**Subject: University of California, Berkeley, Richmond Field Station Site
Final Soil Management Plan, Revision 1
Removal Action Workplan, Attachment C
Site Investigation and Remediation Order I/SE-RAO 07/07-004, Section 5.16**

Soil Management Plan, Revision 1

Removal Action Workplan, Attachment C

**Berkeley Global Campus at Richmond Bay, Richmond,
California**

**FIGURE C-6
HISTORIC RADIOLOGIC USE
AND SAMPLING LOCATIONS**

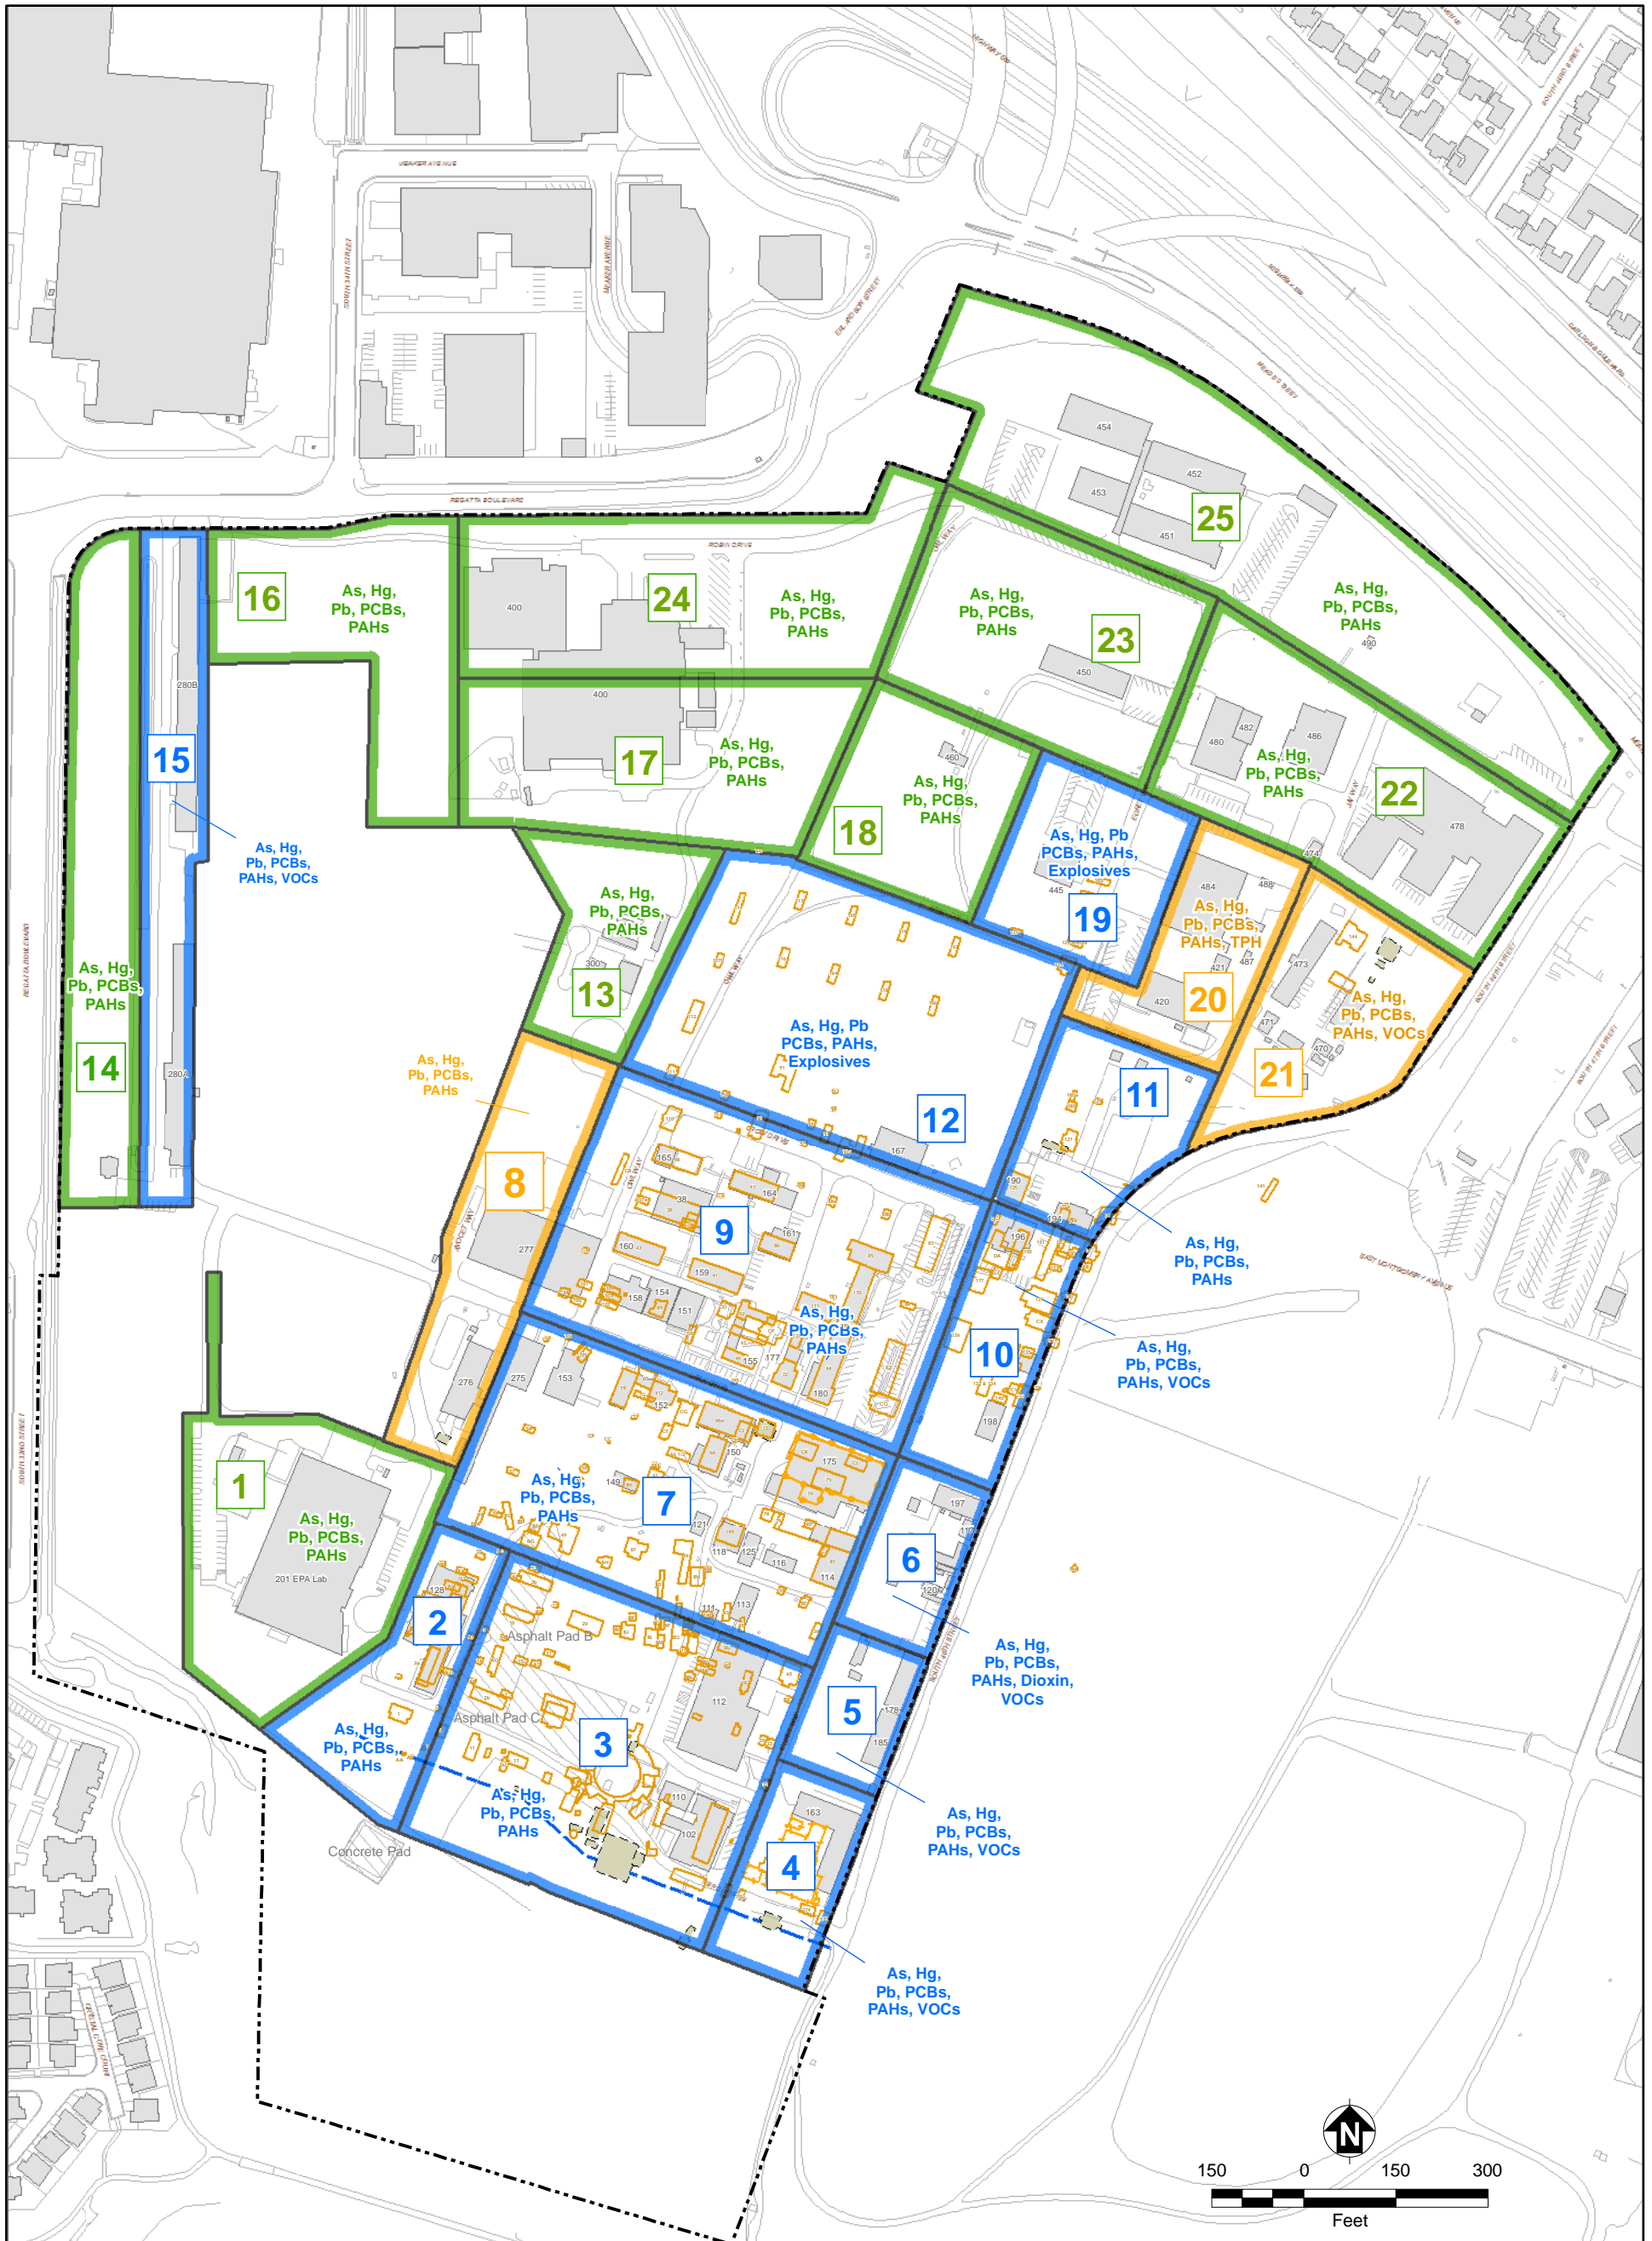
5. Figure C-6, Historic Radiological Use and Sampling Locations: Revise the legend item that indicates that a full list of report references is included on the back of the figure, or include the references.

UC Berkeley Ref. No.	Page, Section, Item	DTSC Comment No.	DTSC Comment	UC Berkeley Response
5	Figure C-6, Historic Radiological Use and Sampling Locations:	5	Revise the legend item that indicates that a full list of report references is included on the back of the figure, or include the references.	Figure C-6 legend has been revised to include a note stating that all radiological reference documents are included in Section 7.0, References. The reference key within Figure C-6 has been updated to include the appropriate references. Section 7.0 References has been updated accordingly.
6	Table C-1: Category I and II Criteria:	6	Revise the Category II On-Site Management criteria for barium from 100,000 to 21,100.	Table C-1 has been revised to indicate the Category II criteria for barium as 21,100 milligrams per kilogram. Section 4.2.1 Screening Criteria was updated to reflect this update.
7	Section 3	7	<p>Add a subsection to Section 3, Types of Work titled: "Dewatering Related to Construction Work". In this subsection, include a requirement that states "In areas with known impacts to groundwater, the following is required:</p> <ul style="list-style-type: none"> a) perform an assessment of current groundwater monitoring reports to determine if there are impacts to groundwater in the work area, prior to installing dewatering wells; b) prevent advancing any borings for dewatering purposes (or installing dewatering wells) which are screened across multiple water-bearing units; c) secure all appropriate permits to discharge to sanitary sewer if dewatering is done in areas where impacts to groundwater are known; d) enforce all groundwater discharge permit requirements including collecting/storing impacted groundwater, batch sampling it, and/or treating it prior to discharge to the sanitary sewer; or e) haul impacted groundwater off-site for proper disposal. 	Section 3 has been updated to include the recommended items a through e noted in DTSC Comment 7.
